Re: Initial Submission Review – Watering Bowl – Site Plan and Conditional Uses
Application Number: DA-2179-00
Case Numbers: 2019-6024-00; 2019-6024-01; 2019-6024-02; 2019-6024-03

Initial Submission Review

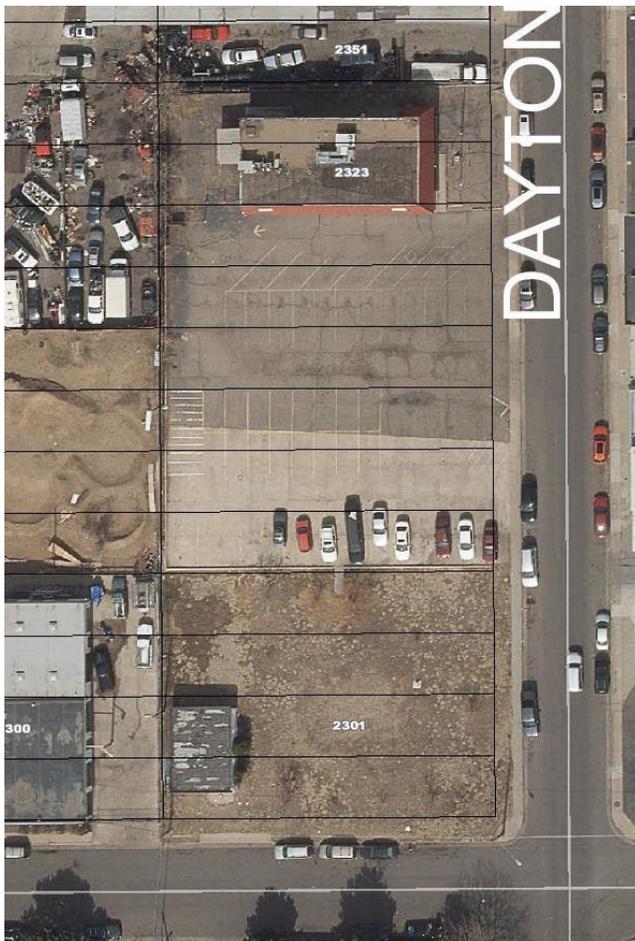
4A. It does not appear that the property lines are shown in the correct locations in the Site Plan. Below is an aerial from the city's GIS system that shows where your property lines are relative to the city-owned rights-of-way. The black lines more or less represent where the property begins. There appears to be around 11' from the edge of the existing curb lines along Dayton Street and 23rd Avenue to the edge of the property. It appears that you are showing about 8'. Please re-survey the site to ensure that the Site Plan is accurate as having the property lines in the incorrect locations would impact the siting of all uses on the property.
